Access Compliance Report

Public Rights-of-Way

(Curb Ramps)

Intersection ID: 11707	Main Street: N_GRAHAM_ST	Cross Street: W_6TH_ST	Location: E
ADA ID: 657F8837DB6D	Ramp Type: BlendTrans1	Initial Pass/Fail: Pass	Overall Compliance: No
			Severity Score: 25.25

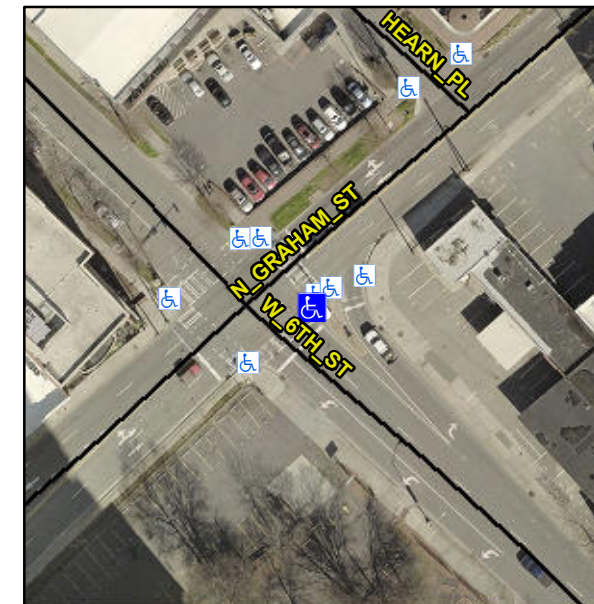
LOCATED ON MEDIAN

Not Found, R304.5.3, R304.2.3, R302.7, R302.7.2, R304.5.4

Compliance	Description	Data	Compliance	Description	Data
N/A	Ramp Length (in)	24.0	Yes	BlendTrans Slope (%)	3.8
Yes	Ramp Width (in)	48.0	No	BlendTrans XSlope (%)	2.6
N/A	Flare Type LT	Sloped	N/A	Flare Type RT	Sloped
No	Flare Slope LT (%)	16.7	Yes	Flare Slope RT (%)	9.7
N/A	Flare Traversable LT?	Yes	N/A	Flare Traversable RT?	Yes
Yes	Landing Length (in)	53.0	Yes	DWS Provided?	Yes
Yes	Landing Width (in)	76.0	Yes	DWS Contrast?	Yes
Yes	Landing Slope (%)	1.9	Yes	DWS Length (in)	24.0
No	Landing X Slope (%)	3.4	Yes	DWS Full Width?	Yes
N/A	Landing Curb? (Y/N)	No	Yes	DWS Offset (in)	0.0
N/A	Shared Landing?	Yes			
No	Gutter Ponding?	Yes	No	Gutter Slope (%)	6.8
No	Gutter Lip Ht (in)	1.0	Yes	Gutter X Slope (%)	1.7
N/A	Painted X Walk1?	Yes	N/A	Painted X Walk2?	N/A
	X Walk 1 Direction	To SW		X Walk 2 Direction	N/A
	X Walk 1 Width (in)	78.0		X Walk 2 Width (in)	N/A
	X Walk 1 Slope (%)	3.4		X Walk 2 Slope (%)	N/A
	X Walk 1 X Slope (%)	2.5		X Walk 2 X Slope (%)	N/A

Yes	Ramp inside XWalk1?	Yes	N/A	Ramp inside XWalk2?	N/A
	Road Slope (%)	2.5		Clear Space?	Yes
	Road X Slope (%)	3.4	N/A	Clear Space to XWalk (in)	N/A
Yes	Any Obstructions?	No	Yes	Storm Grate/Utility Hazard?	No
	Obstruction Type			Storm Grate/Utility Type	
		N/A			N/A
			Yes	Surface Condition? (G/P)	Good
			No	Curb Slope (%)	9.2

Remove & Replace Curb Ramp With Two New Directional Ramps or Equivalent. Remove & Replace Gutter.
